Reviewer 1:

This work tested multiple actinic flux optical designs based on commercially accessible materials for field use. Actinic flux optics are generally in short supply. Thus, the efforts in this work to produce low-cost actinic flux optics would greatly benefit the scientific community. Unfortunately, the paper lacks sufficient detail to assess the designs and quality of the resulting measurements. Most importantly:

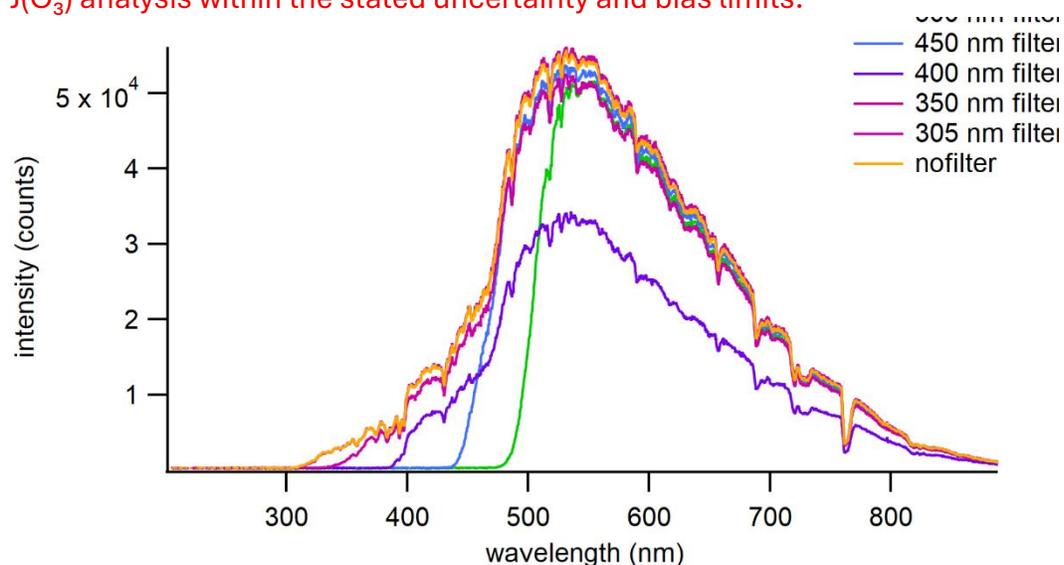
Lines 136-40: The stray light assumptions are not correct and the claim of insignificant stray light from the low-cost spectrometer in this experiment is highly improbable. Stray light correction is vital for atmospheric single monochromators measurements in the UV-B. The issue lies in the 4-5 orders of magnitude difference in light intensity between 300 and 400 nm. A fraction of a percent of the visible light scattered inside the spectrometer (stray light) and hitting the 300 nm pixel easily overwhelms the signal. Thus, careful UV-B stray light characterization is necessary to measure actinic flux and calculate UV-B sensitive photolysis frequencies, particularly jO_3 .

Jäkel et al., 2007 provides an analysis technique using a series of long pass filters that demonstrate the influence of broad spectral regions on UV-B signals. Unfortunately, this work relied on thin, isolated mercury lines that are insufficient to demonstrate the effect. I am unclear if the current analysis even includes a dark correction to remove the electronic offset inherent in CCD spectrometers. The only clue is in the data files that log the “Electric dark correction enabled” is labeled “true”.

Unless convincingly proven otherwise, this small spectrometer should be presumed to have a significant or overwhelming stray light effect in the UV-B. I would strongly recommend foregoing UV-B and jO_3 analysis with this spectrometer without a full consideration of stray light and dark current. Unfortunately, the TUV comparison for jO_3 does not alleviate the concerns (see comments below). Again, direct comparison with established instrumentation would definitively determine the accuracy and appropriateness of this system for jO_3 measurements.

The reviewer is correct that UV-B actinic-flux measurements are particularly sensitive to stray light in single-monochromator/CCD systems because visible and UV-A radiance can exceed UV-B by several orders of magnitude. The original manuscript description, which referenced isolated Hg lines, was insufficient to rigorously bound UV-B stray light.

A quantitative stray-light assessment was therefore performed using the long-pass filter technique described by Jäkel et al. (2007). A series of long-pass edge filters was applied under identical acquisition settings, and the residual signal recorded below each cut-on wavelength was used to establish a wavelength-resolved upper bound on out-of-band

contributions. After dark correction, the maximum stray-light contribution in the UV-B region was <0.16% of the in-band signal under the tested conditions.

The Methods section now explicitly states that electronic dark correction was enabled during acquisition and that all spectra were dark-corrected prior to conversion to actinic flux. The long-pass filter spectra used to derive this bound are provided as Figure R1 in the response package.

These additions directly address the UV-B stray-light concern and support inclusion of the $J(O_3)$ analysis within the stated uncertainty and bias limits.
